St. Benedict's Church
Traffic Control Plan (TCP) for
Church Services and Events

PLAN NOTES (JULY 2018)

REVISIONS	DATE
See "Plan Notes (2018)"	7/10/18

SHT NO. : 1

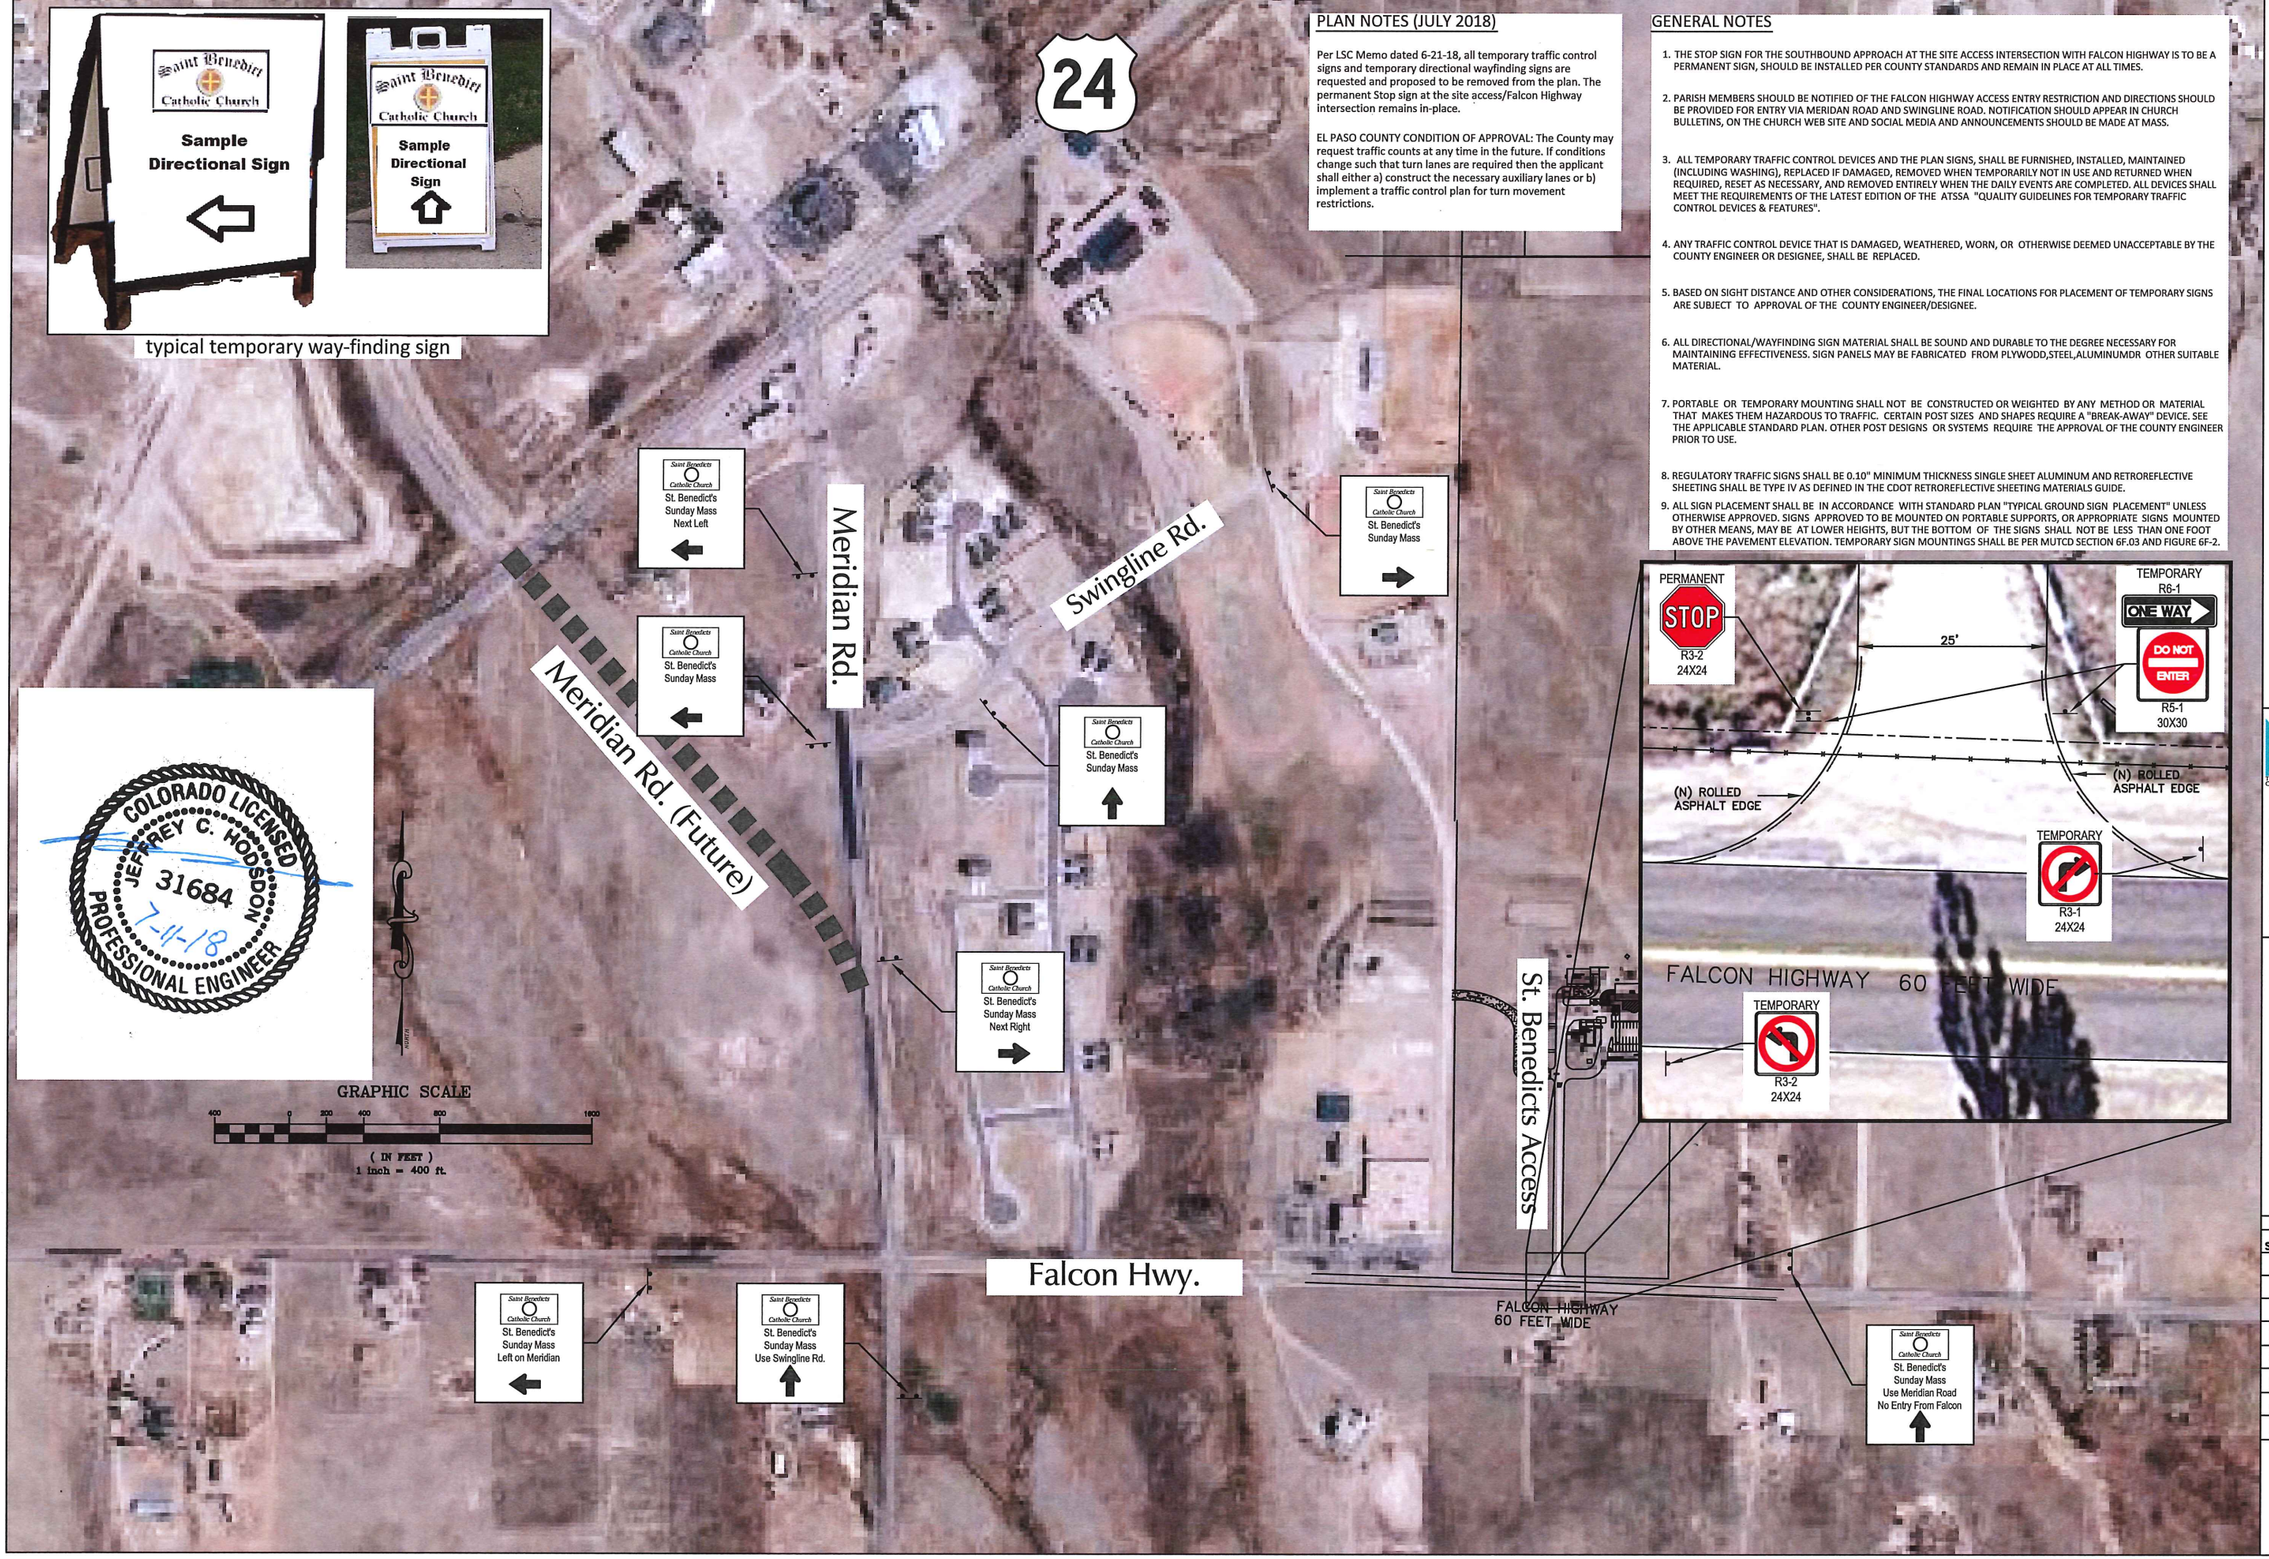
Per LSC Memo dated 6-21-18, all temporary traffic control signs and temporary directional wayfinding signs are requested and proposed to be removed from the plan. The permanent Stop sign at the site access/Falcon Highway intersection remains in-place.
